Project	One Park Place, Manchester
Report Title	Fire Engineering Review
Our Ref	HM2442/R1 Issue 1

Report Title Fire Engineering Review

Report No. HM2442/R1
Issue No . Issue 1
Issue Date. 18/08/2023

Figure 3- Stair Arrangement

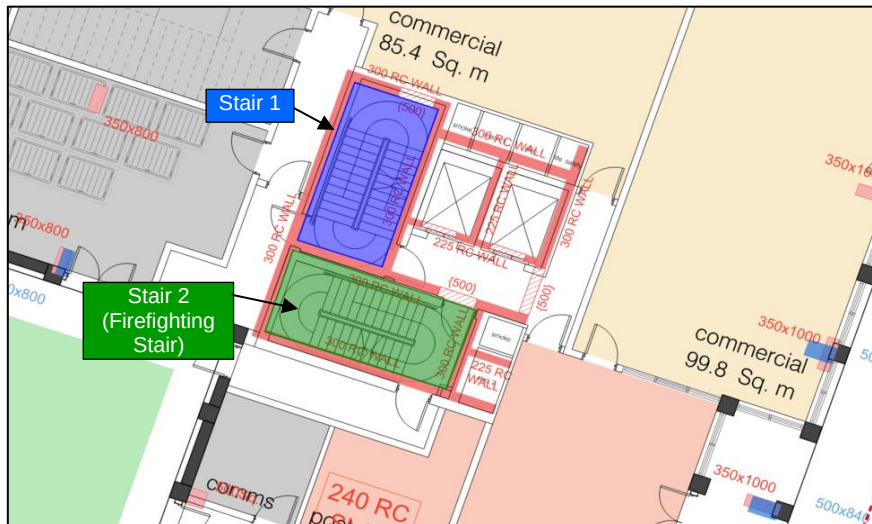
The building will be served by two stairs. The stair arrangement is shown in Figure 3. Stair 2 should be designed as a firefighting stair and should be at least 1.1m wide. Both stairs should be provided with a 1m² AOV at the head.

Figure 4- Ground Floor Layout

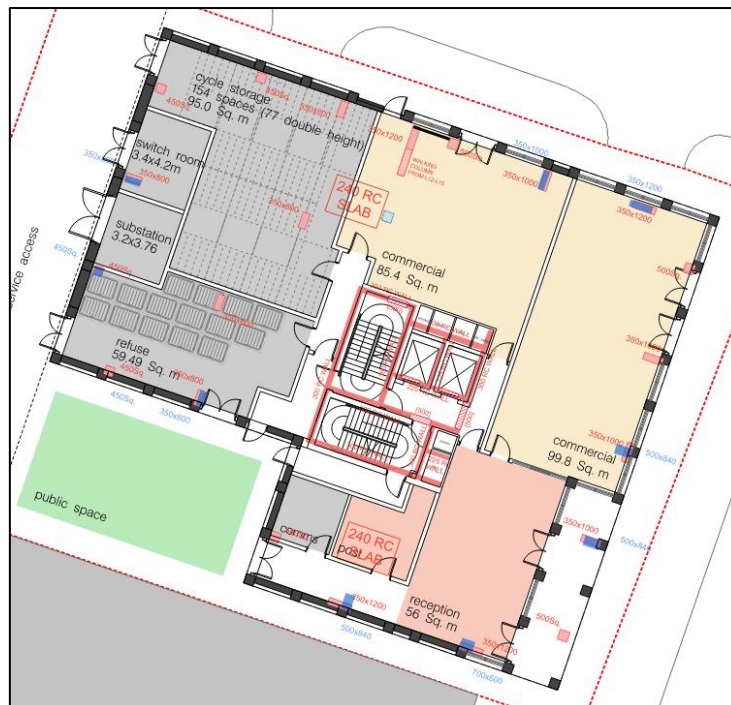
Building Regulations guidance recommends that the stairs should discharge directly to outside or to outside via a protected corridor. Protected escape routes are provided however there are connections to ancillary accommodation such as the refuse store and reception which should be provided with smoke vented lobbies.

The refuse store and cycle store share a direct connection to the Stair 1 escape route at ground. The stair final exit route should not connect to ancillary accommodation.

Figure 5- Venting of Refuse Store/ Cycle Store Lobby

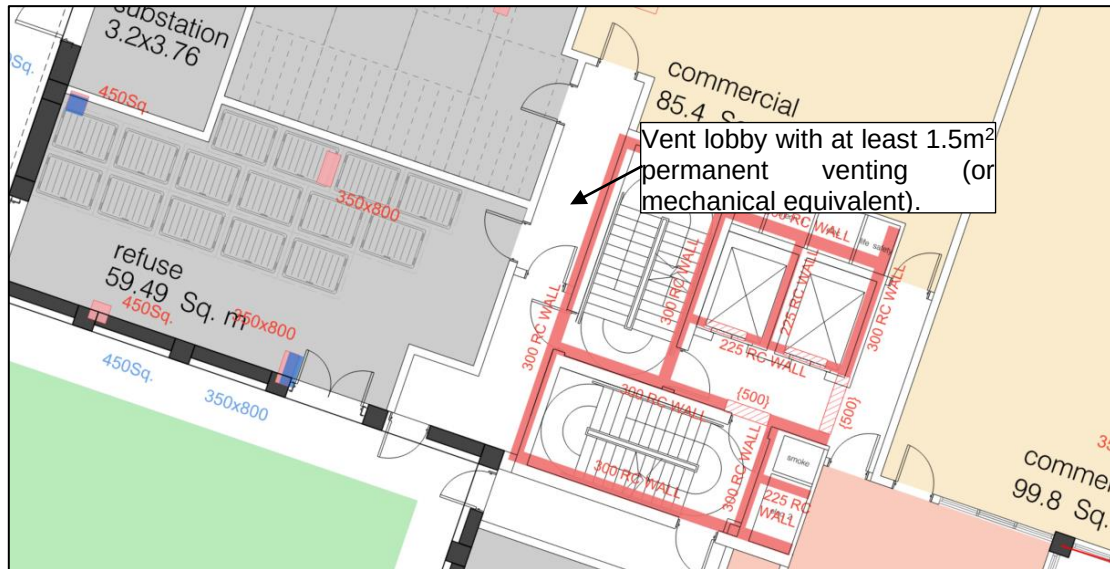
To support this layout the lobby serving the refuse store and cycle store should also be vented with 1.5m^2 permanent venting or the mechanical equivalent. Typically, 0.4m^2 venting is sufficient to a refuse store lobby however the venting requirements should match that of the residential stair to provide a sufficient degree of protection. The arrangement is shown below in Figure 5.
